Univent Replacement at Stony Point, Thiells, and West Haverstraw Elementary Schools

MSA File No. 43040

NOTICE TO BIDDERS

Re: **ADDENDUM NO. 2**

SPES-A-401

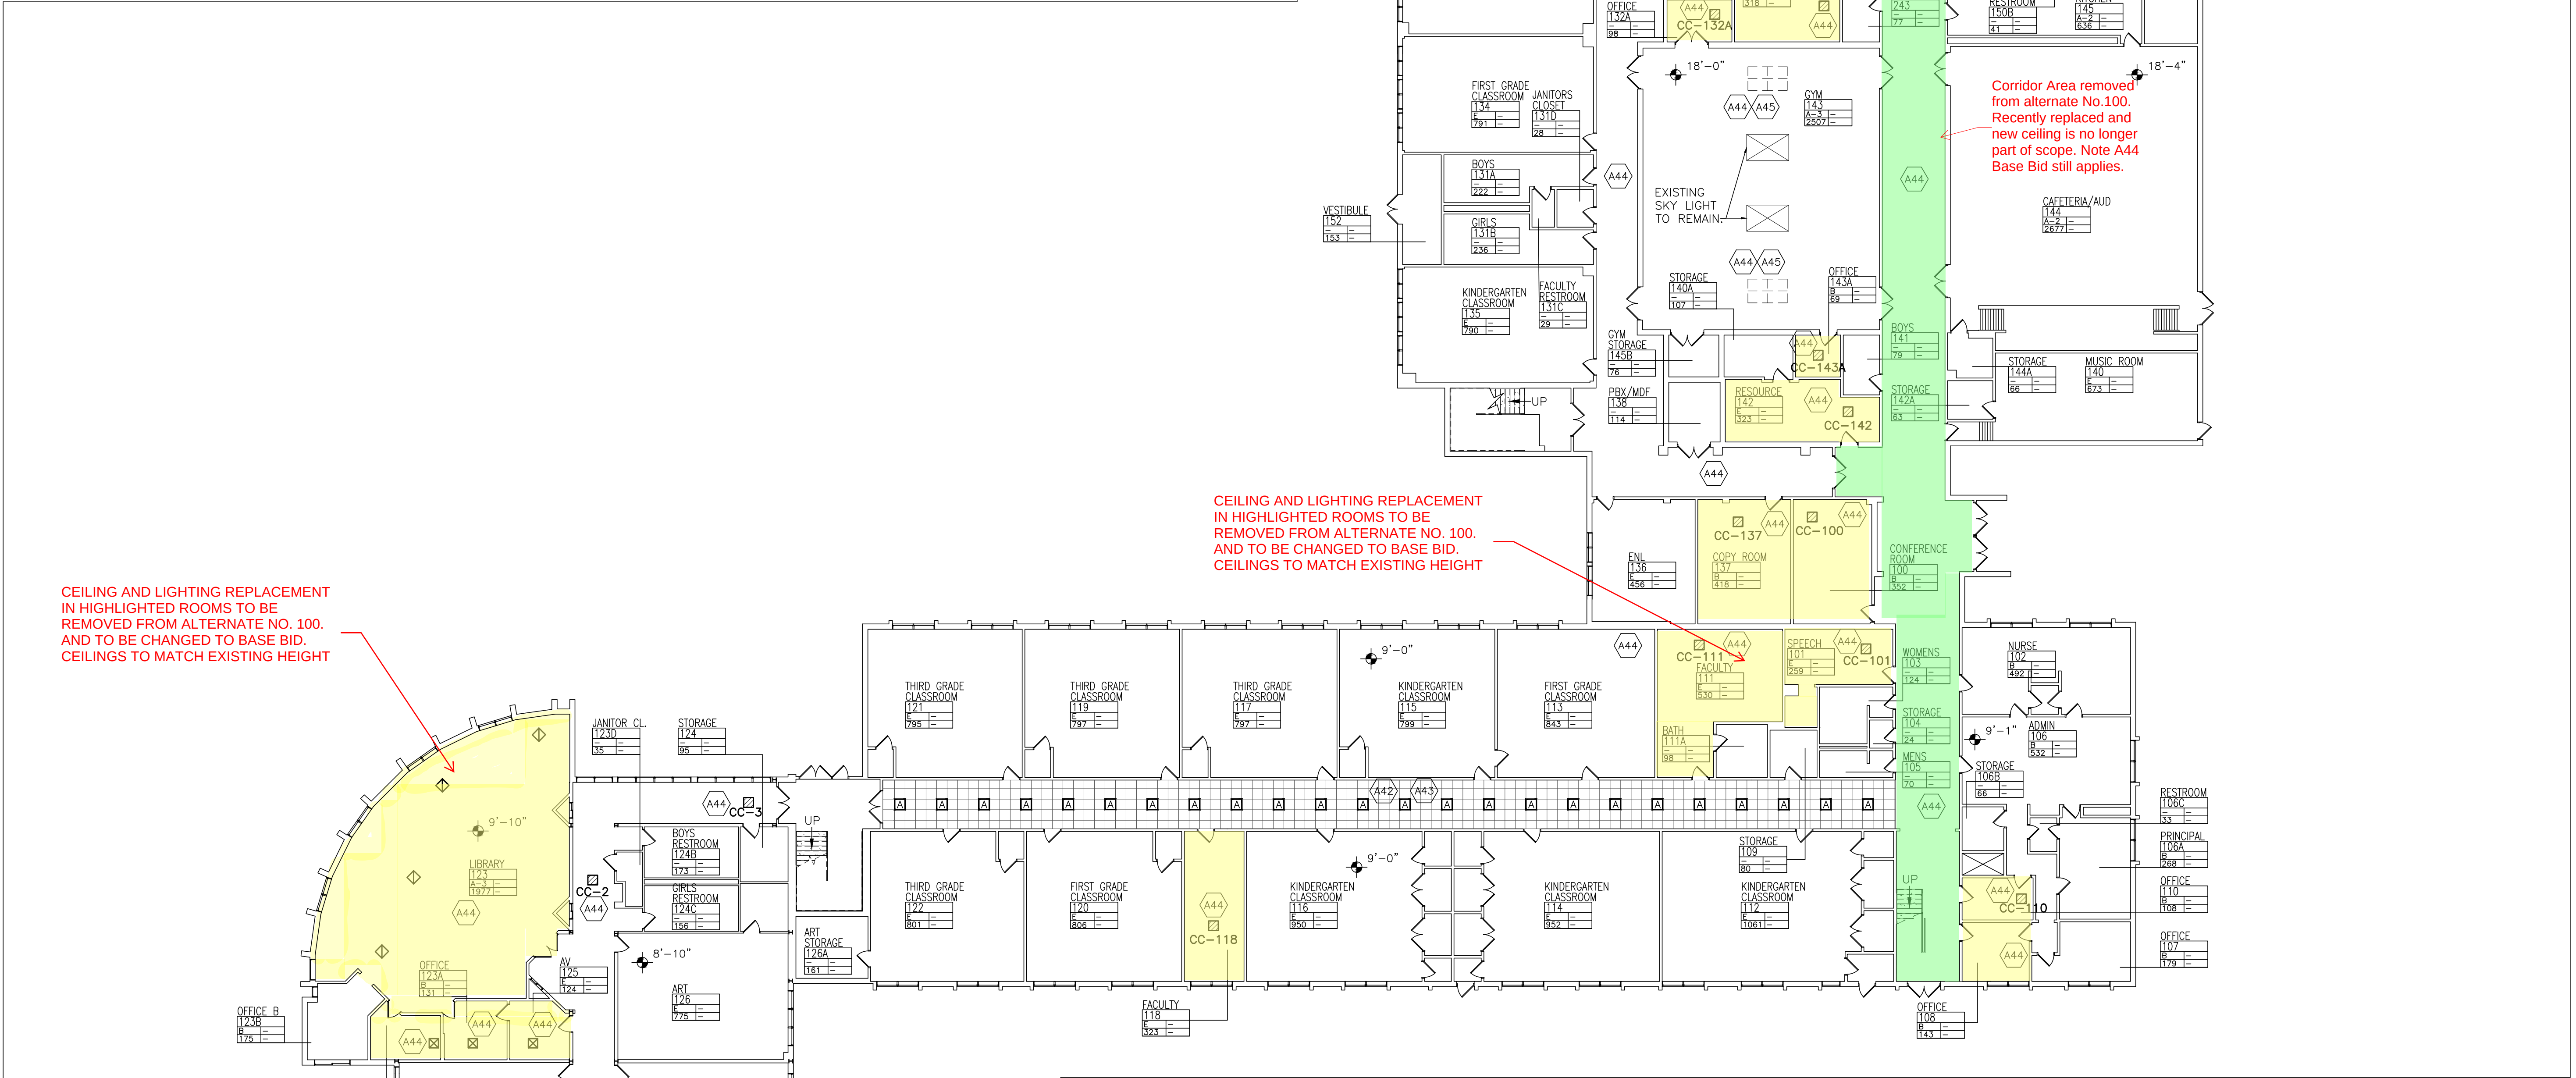
- 7) Revisions for Ceiling Replacement at Stony Point Elementary. See attached Markup drawing SPES-A-401 & SPES-A-402. The ceiling replacement of the highlighted ceilings in yellow will now be base bid. Exclude those areas from Alternate No. 100. The highlighted area in green will not require new ceilings and to be excluded from Alternate No. 100.

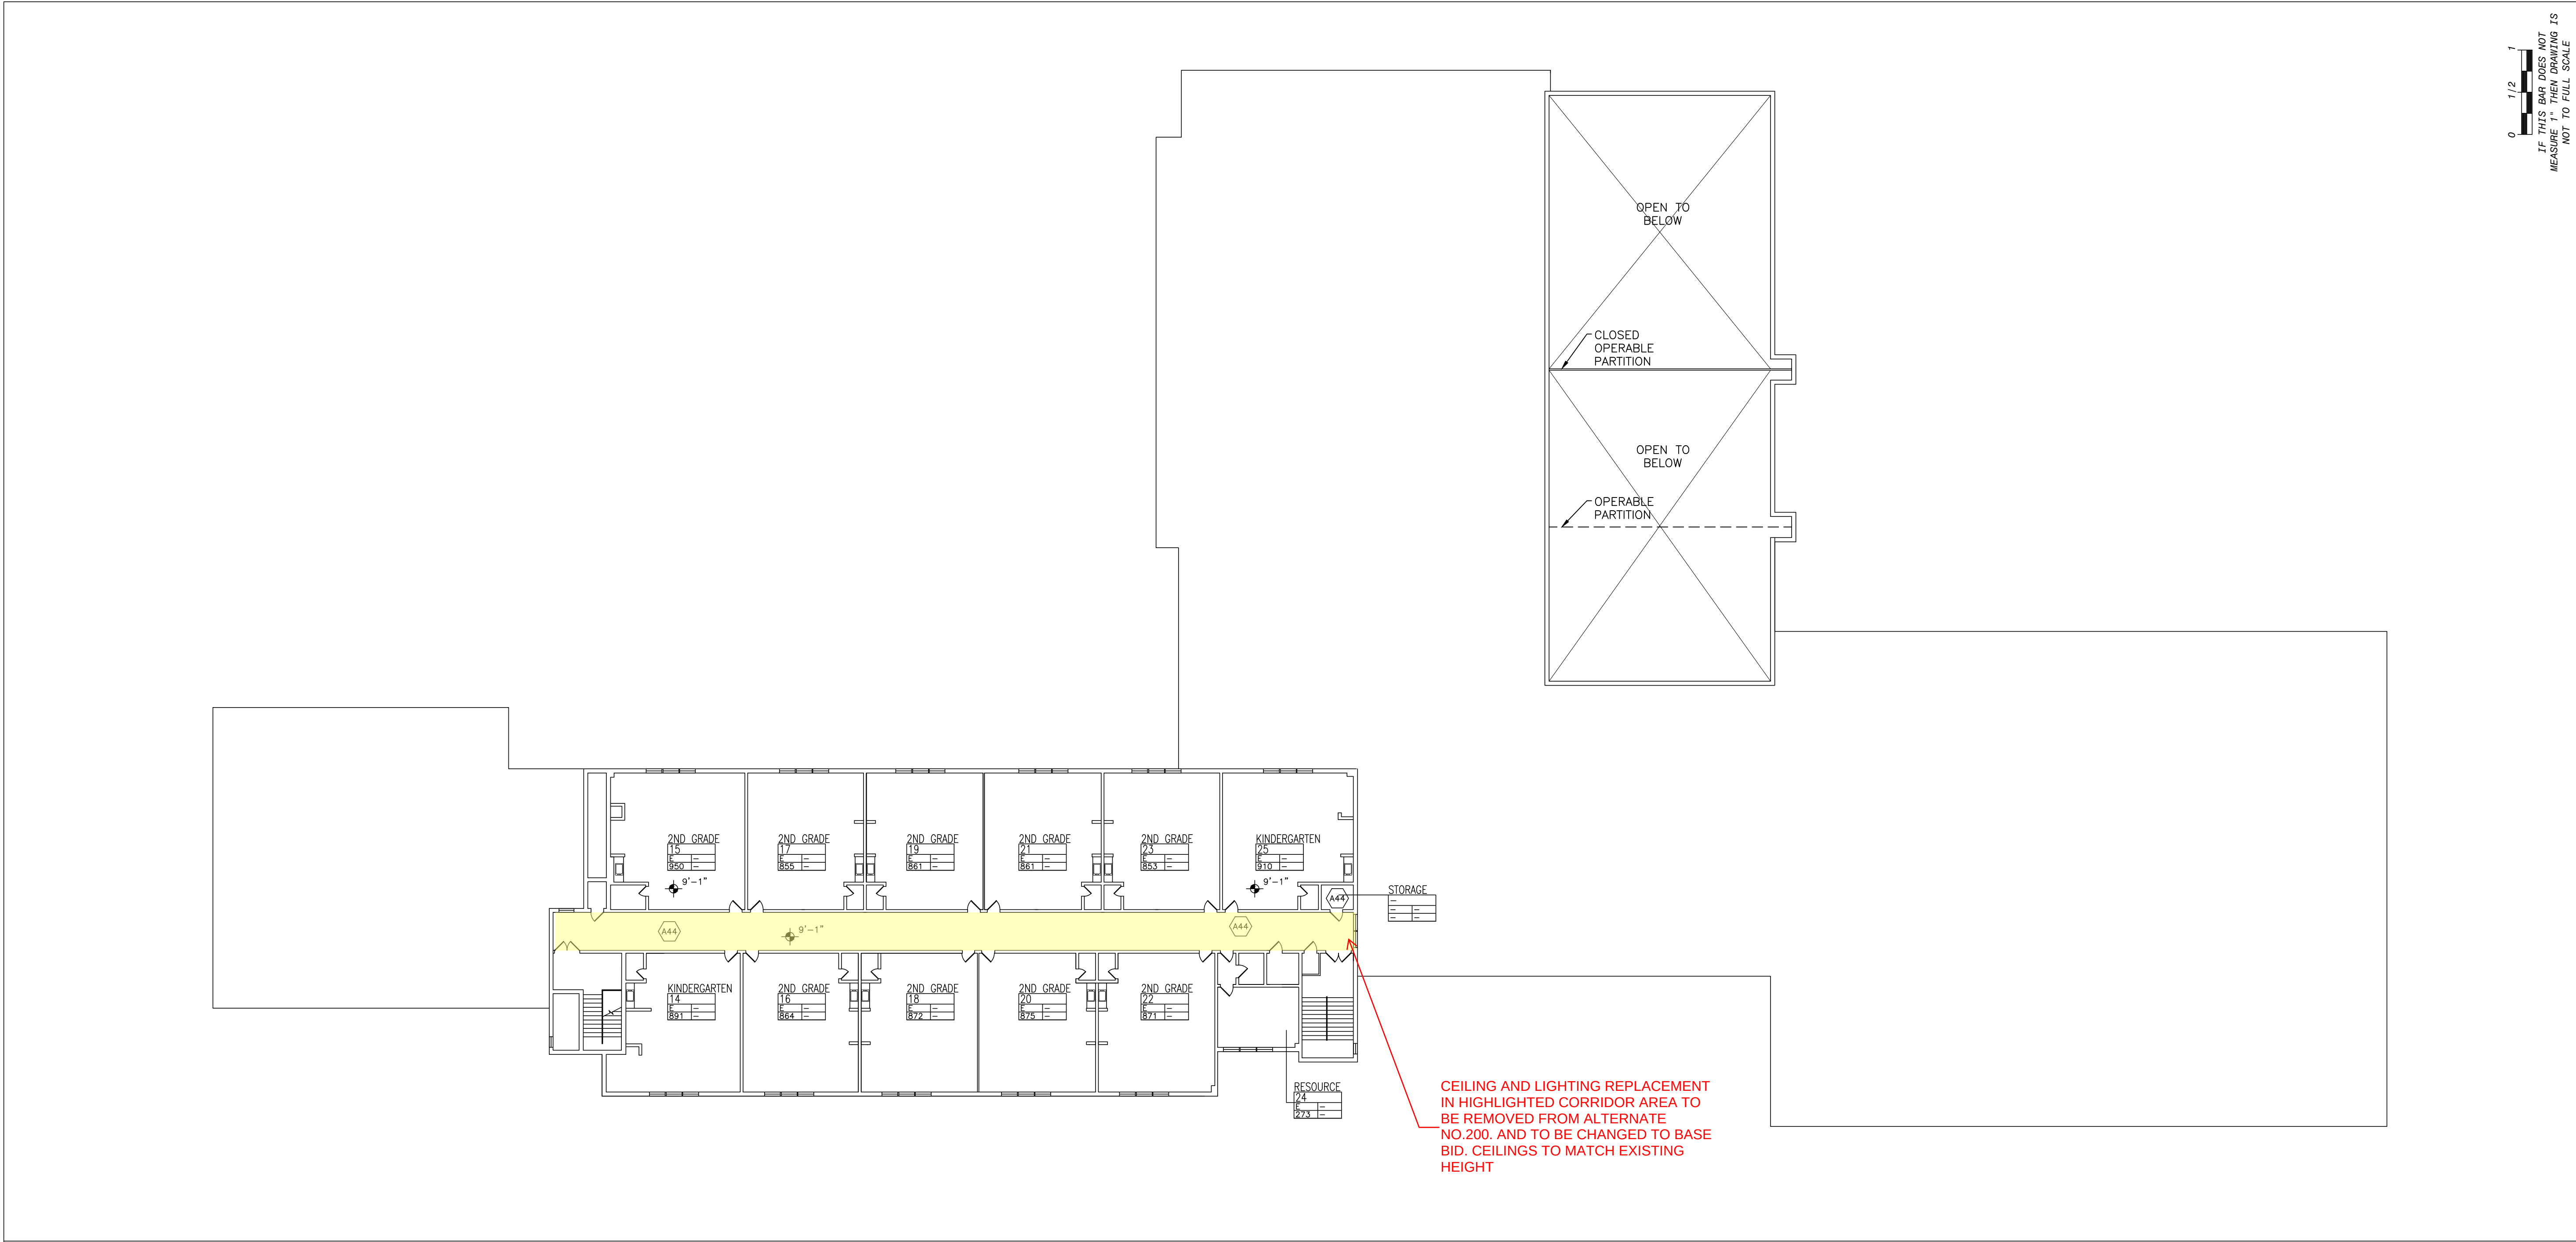
- 8) Revisions for Ceiling Replacement at Thiells Elementary School. See attached Markup drawings TES-A-401 & TES-A-402 highlighting locations to receive new ceilings as part of base bid. Exclude those areas from Alternate No. 200.
- 9) Revisions for Ceiling Replacement at West Haverstraw Elementary School. See attached Markup drawings WHES-A-401 & WHES-A-402 highlighting to receive new ceilings as part of base bid. Exclude those areas from Alternate No. 300.
- 10) See attached revised specification section 011200 Multiple Contract Summary.
- 11) See attached Construction Schedule.
- 12) See attached Phasing and Logistics Plans.
- 13) Equipment Screening at Thiells Elementary School and West Haverstraw Elementary School. See attached revised drawings TES-A-103 and WHES-A-103. Drawing A-500 was revised and provided as part of Addendum No. 1.

Drawing No. WHES-A-101

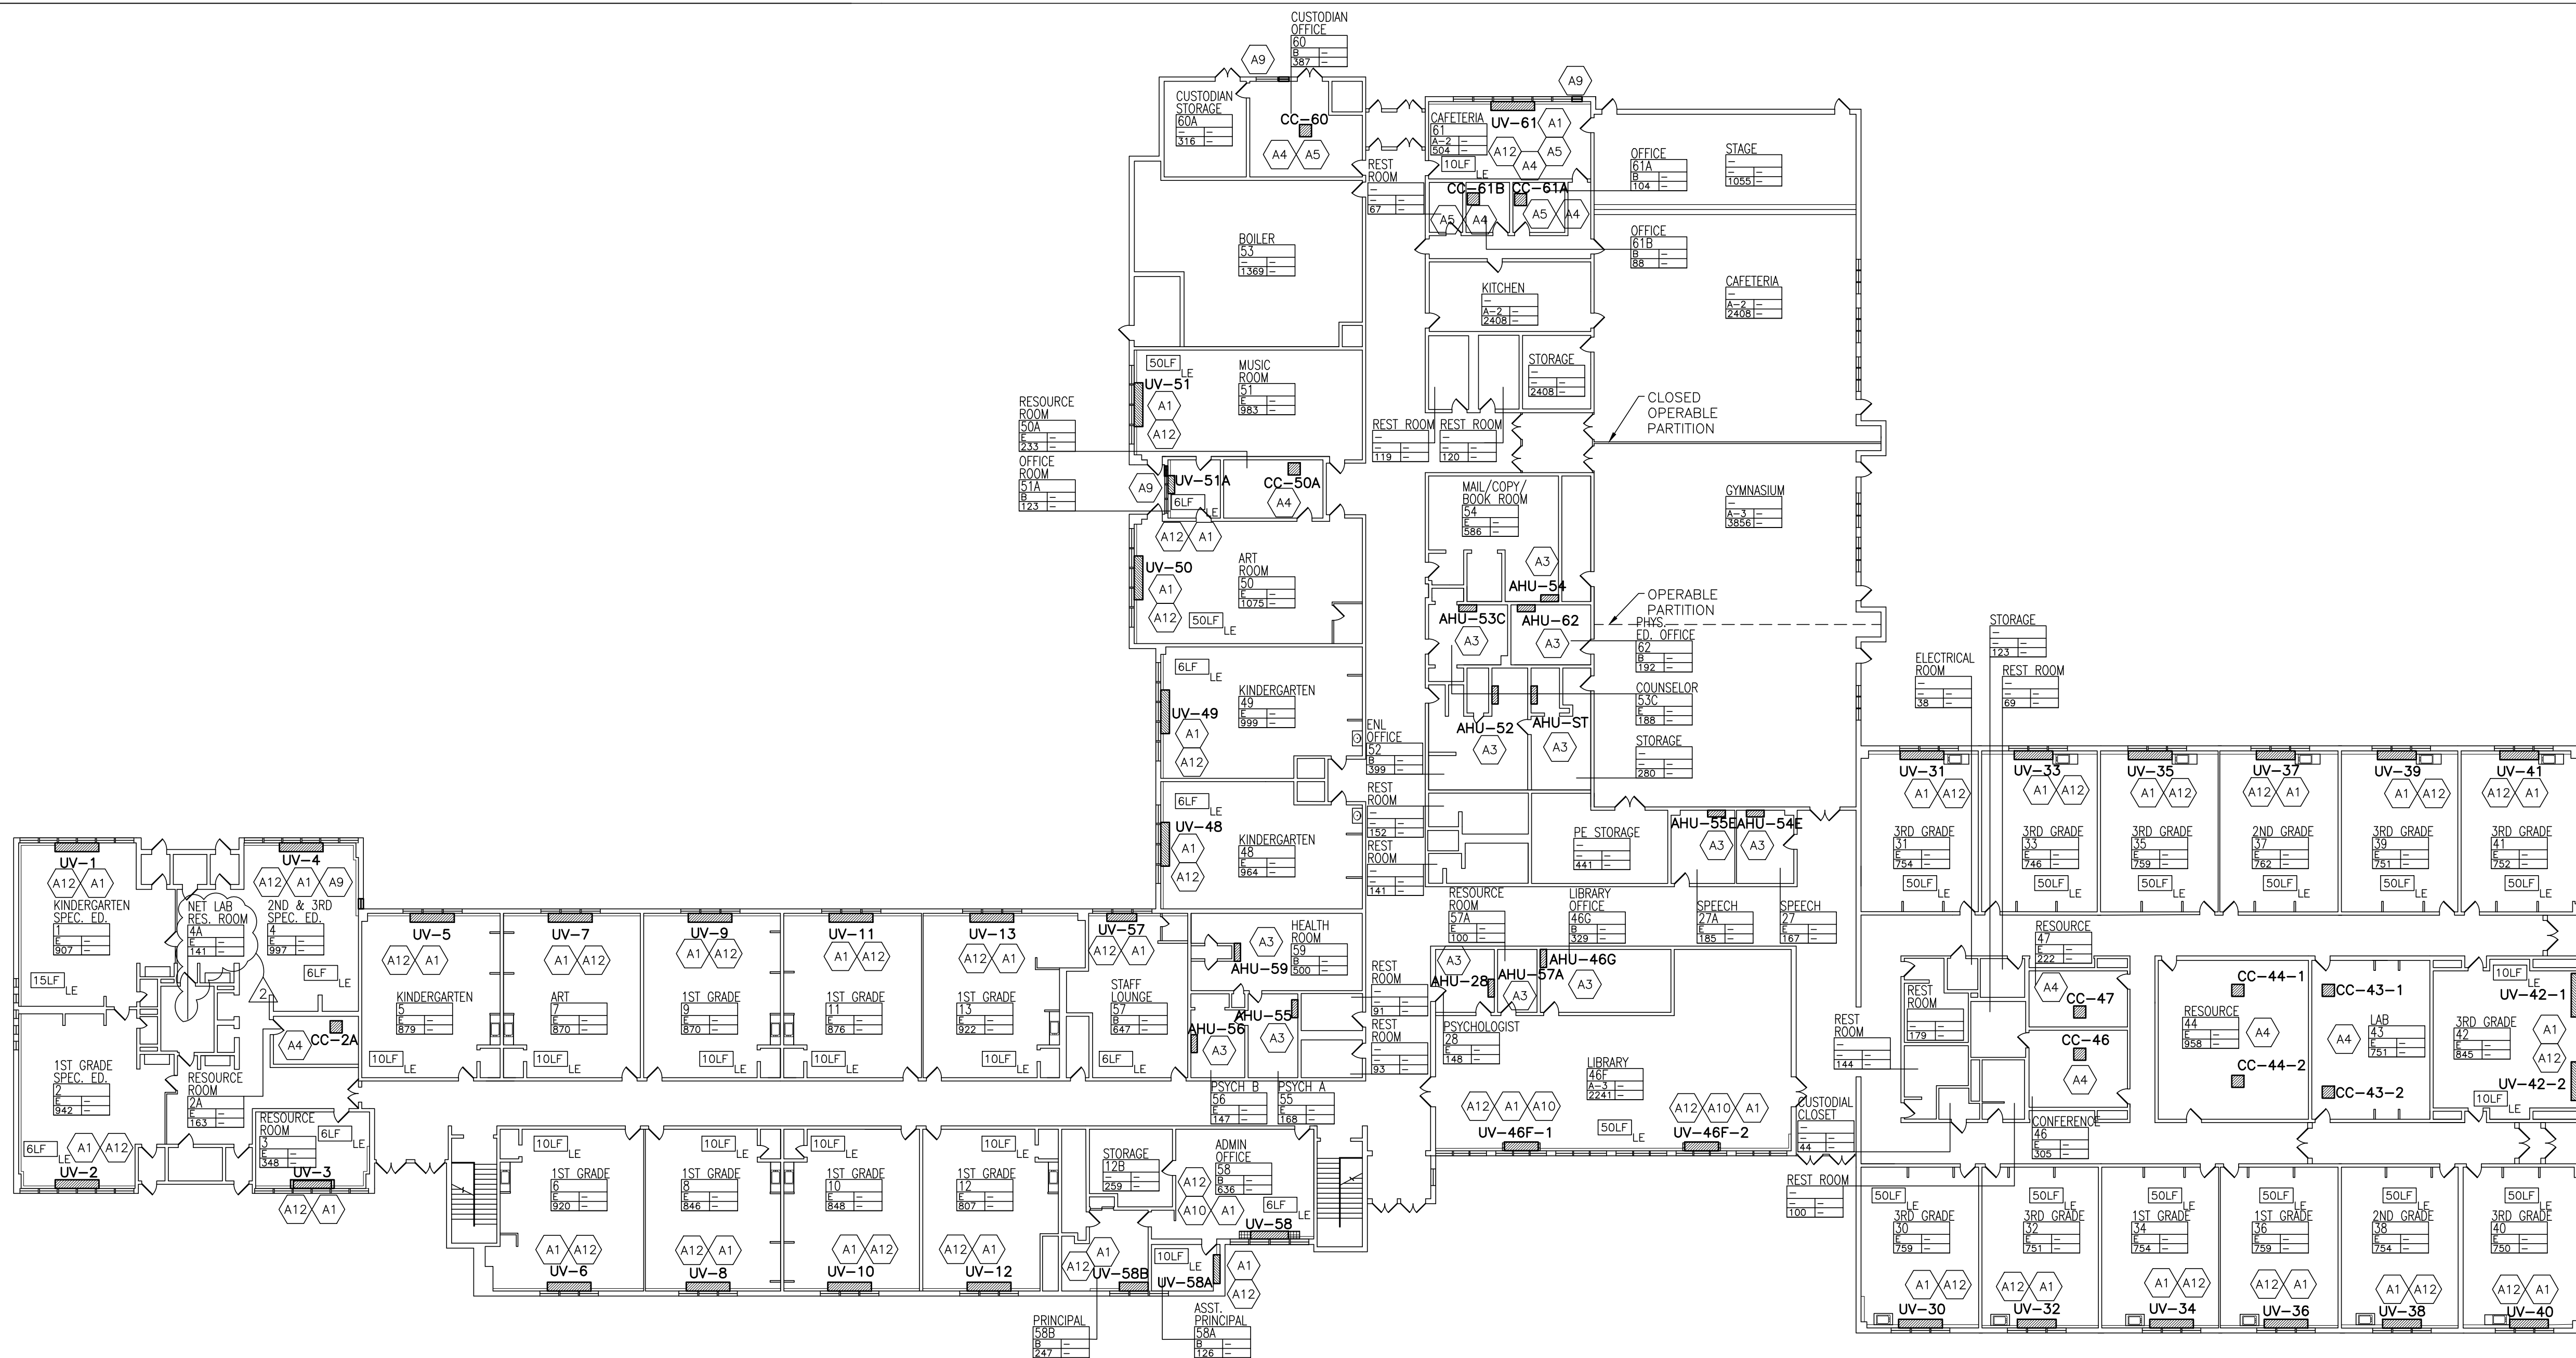
- 6) See attached revised plans TES-A-101 and WHES-A-101 including the room tags of the rooms to receive ceiling cassettes related to Alternates No. 201 and 301.
